**ADDENDUM NO. 14**

**PROJECT NO. DGS C-0948-0090 PHASE 003**

**PROJECT TITLE - Capitol Complex Central Plant - Building Renovations, Chiller System  
Replacement and Electrical System Upgrades**

**ADDENDUM NO. 14**

ELECTRICAL VAULT PLAN - PLUMBING NEW WORK

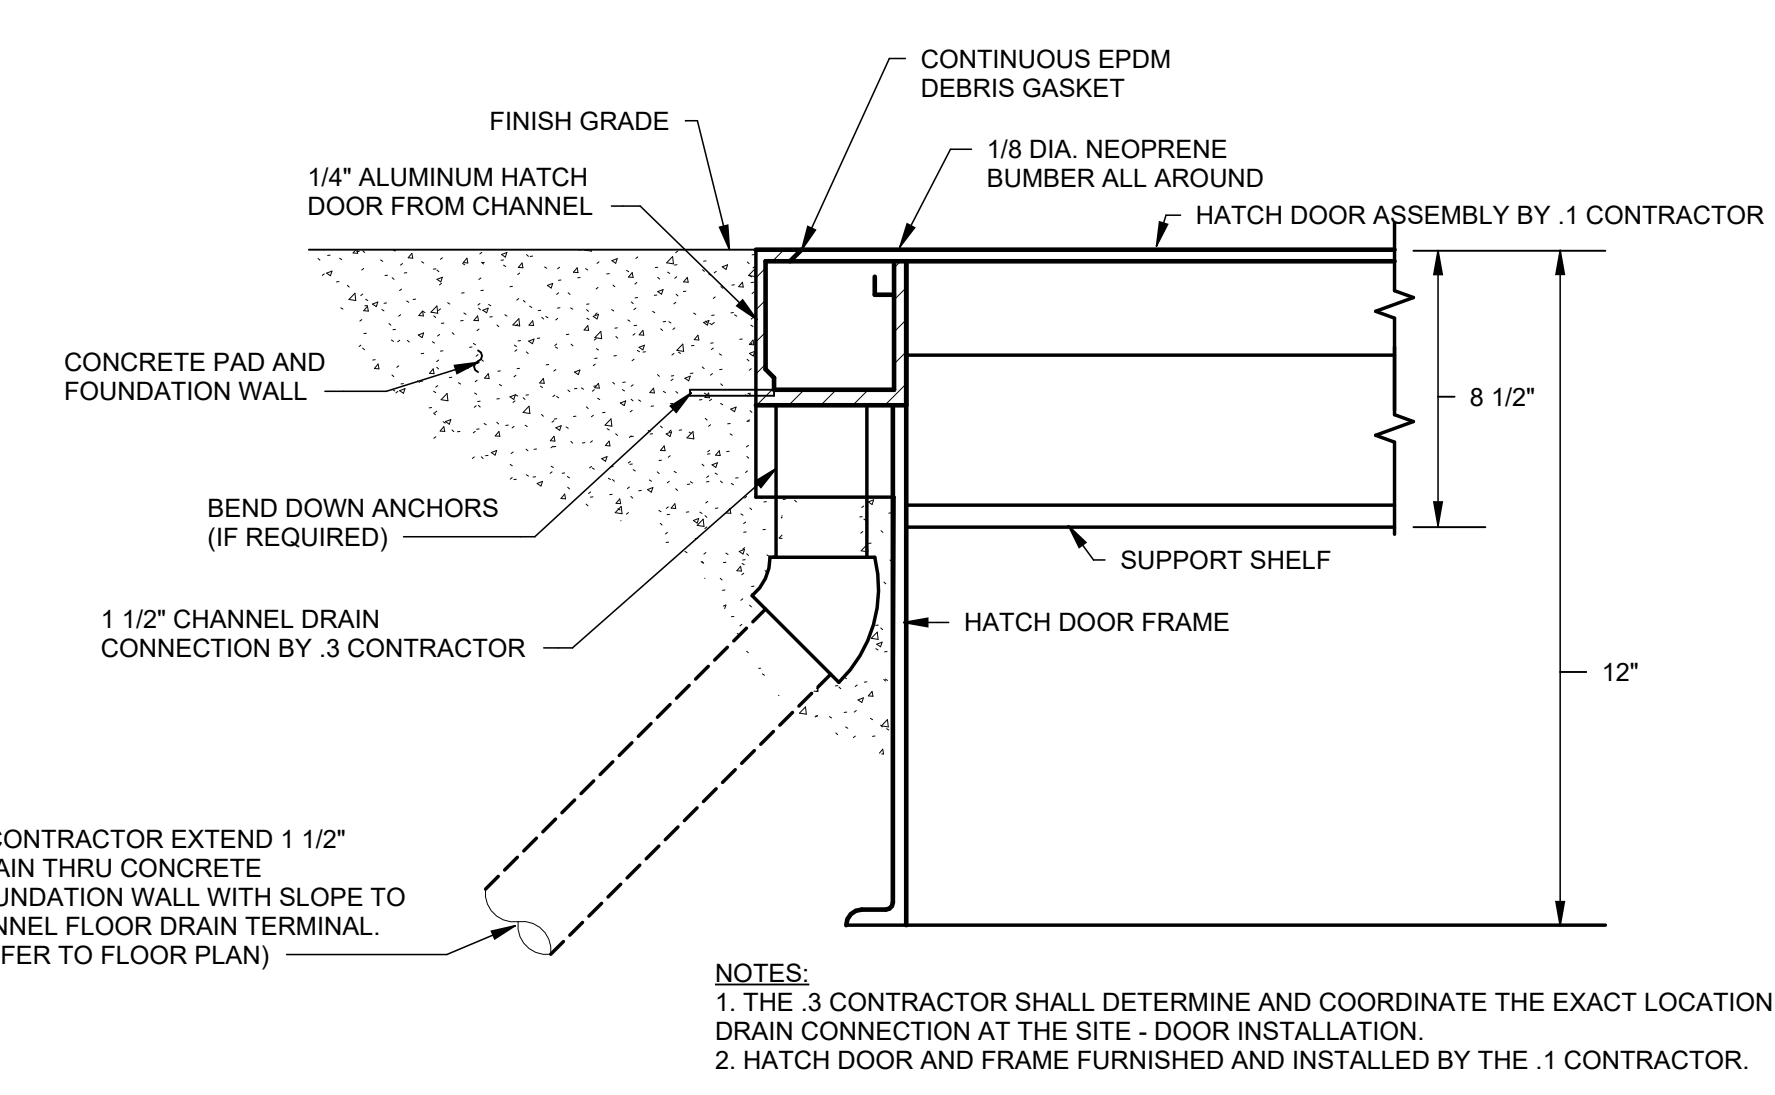
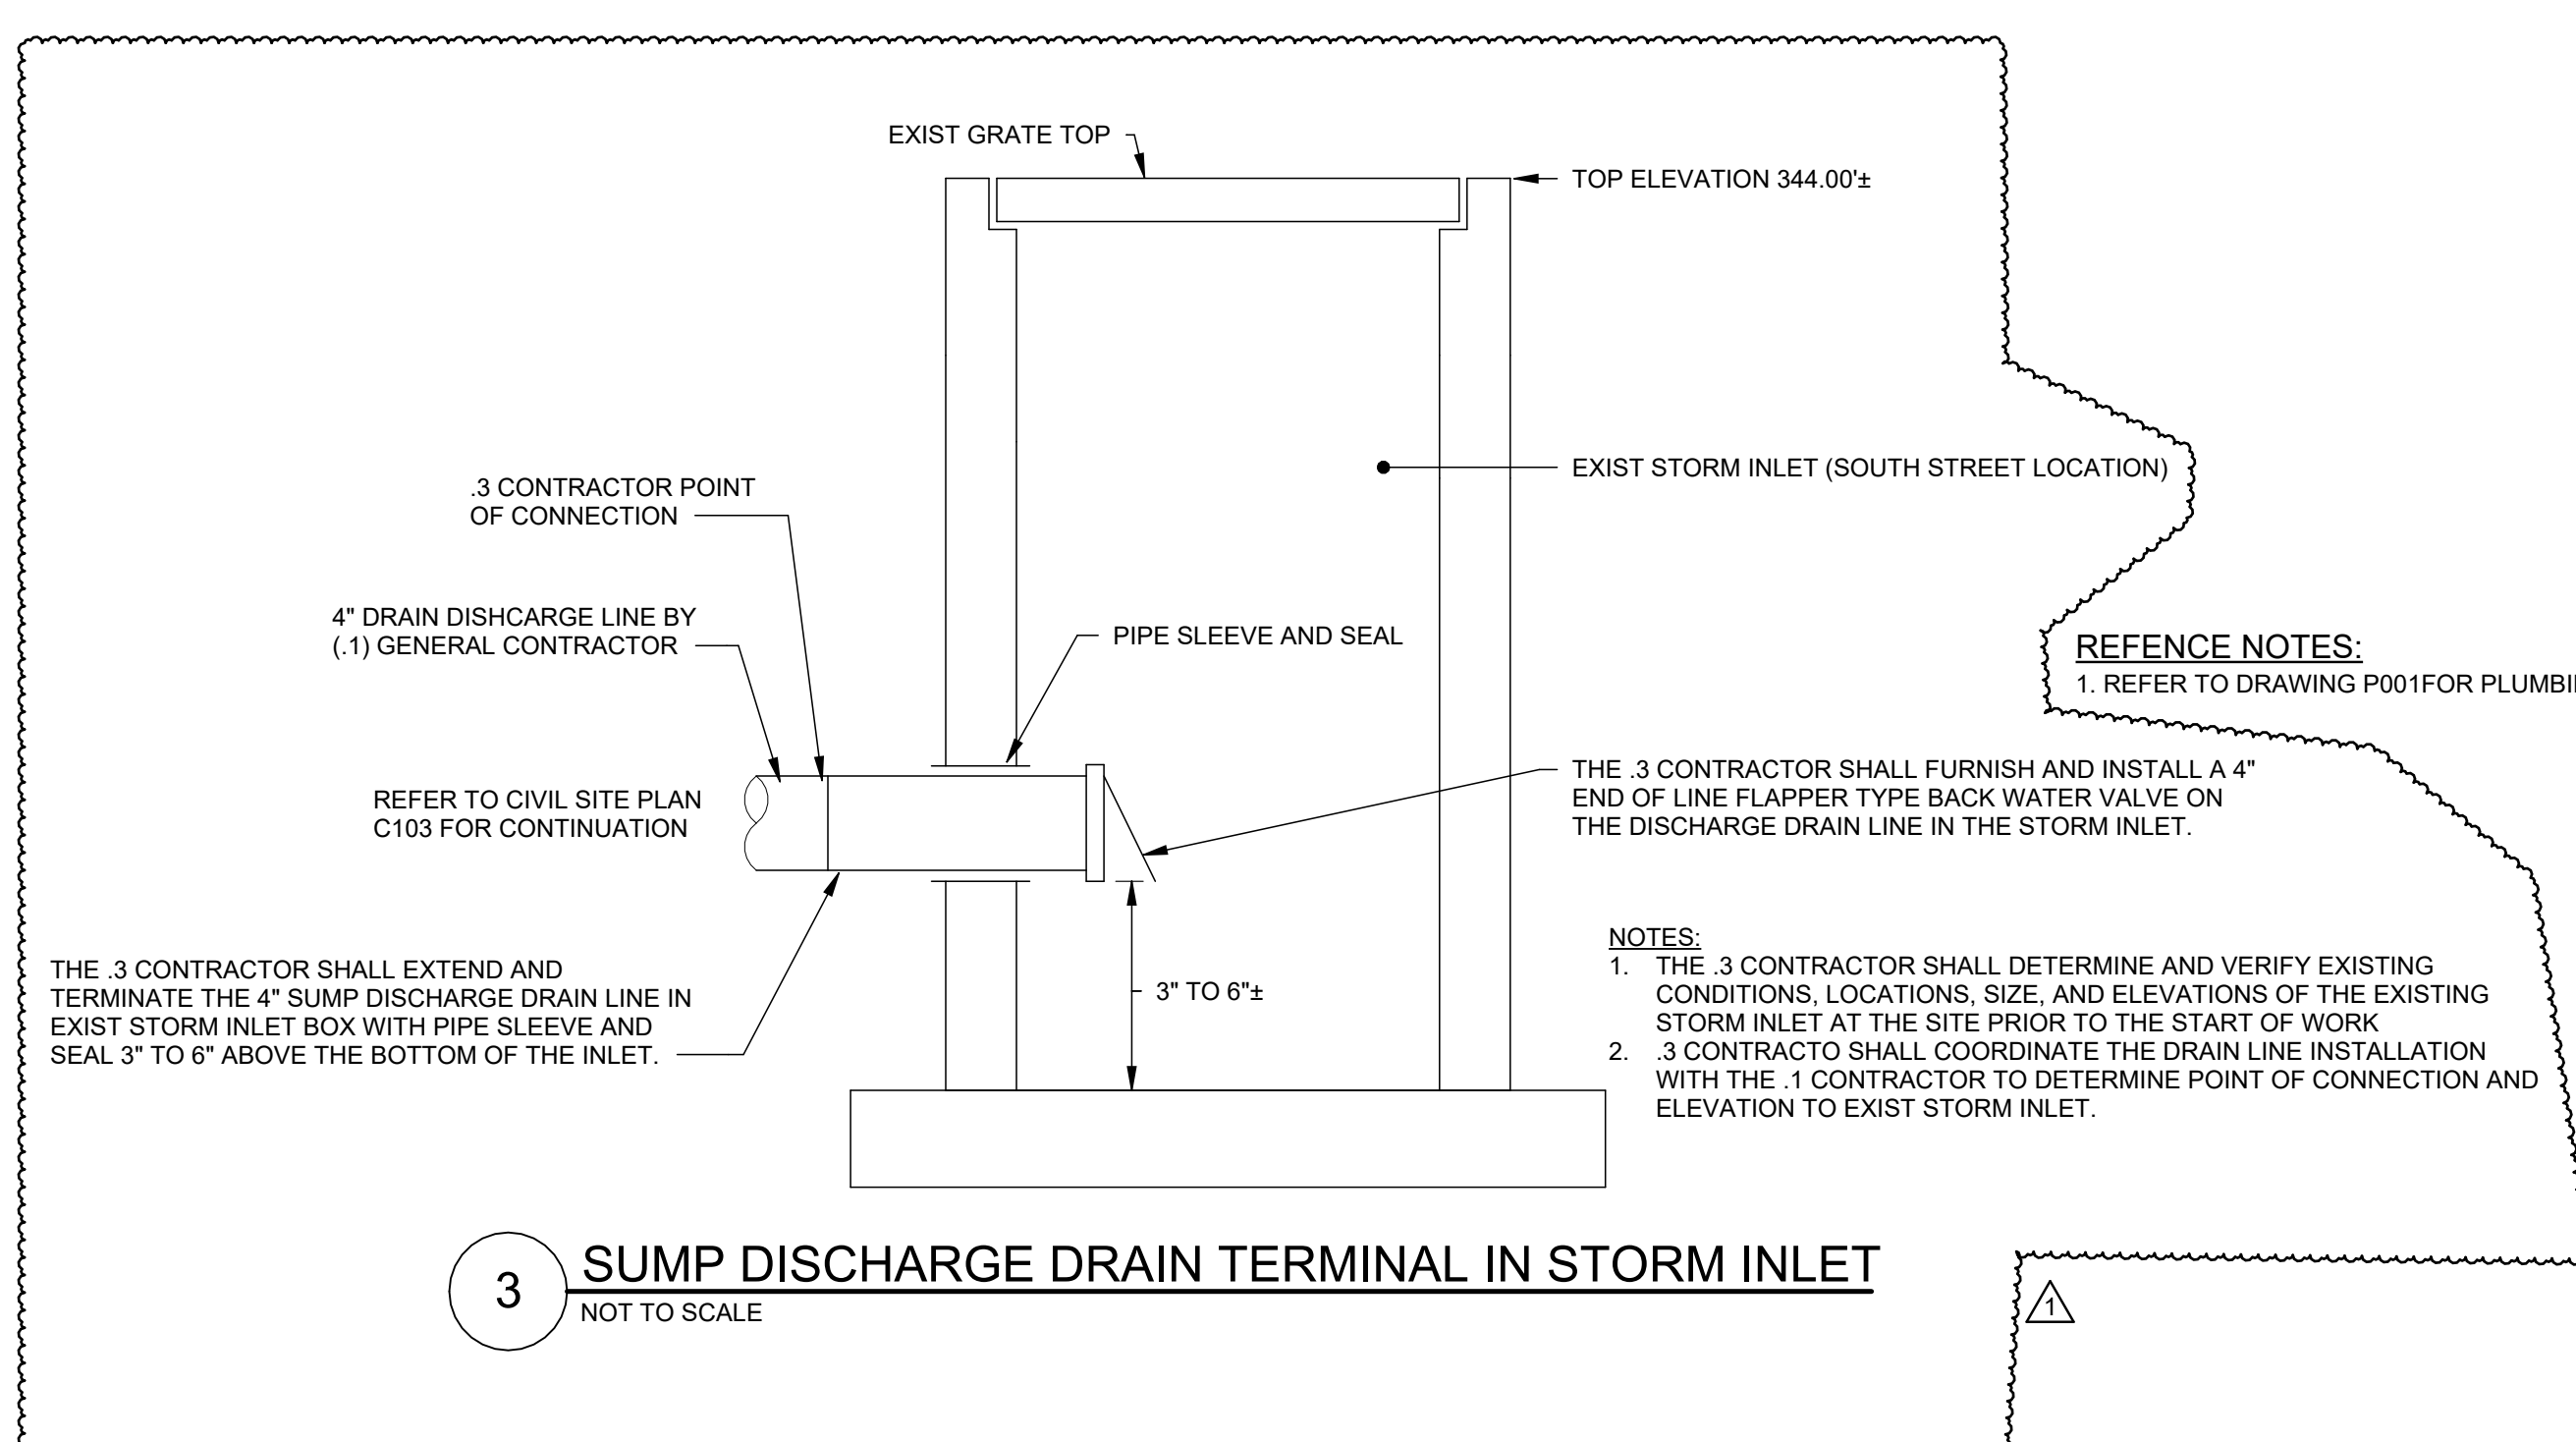
- 1 FURNISH AND INSTALL FREEZE PROTECTION HEAT TAPE AND INSULATION ON COLD WATER PIPING. (TYPICAL)
- 2 FURNISH AND INSTALL FREEZE PROTECTION HEAT TAPE AND INSULATION ON PUMP DISCHARGE PIPING. (TYPICAL)
- 3 THE 1 SITE GENERAL CONTRACTOR WILL CONNECT AND EXTEND THE 4" DRAINAGE PUMP DISCHARGE PIPING - BELOW GRADE TO THE DESIGNATED EXISTING STORM INLET LOCATED ON SOUTH STREET - THE 3 CONTRACTOR SHALL EXTEND AND TERMINATE THE 4" SUMP DISCHARGE LINE IN THE STORM INLET BOX WITH 4" END OF LINE FLAPPER TYPE BACKWATER VALVE (REFER TO STORM INLET BOX DETAIL #3/P202)
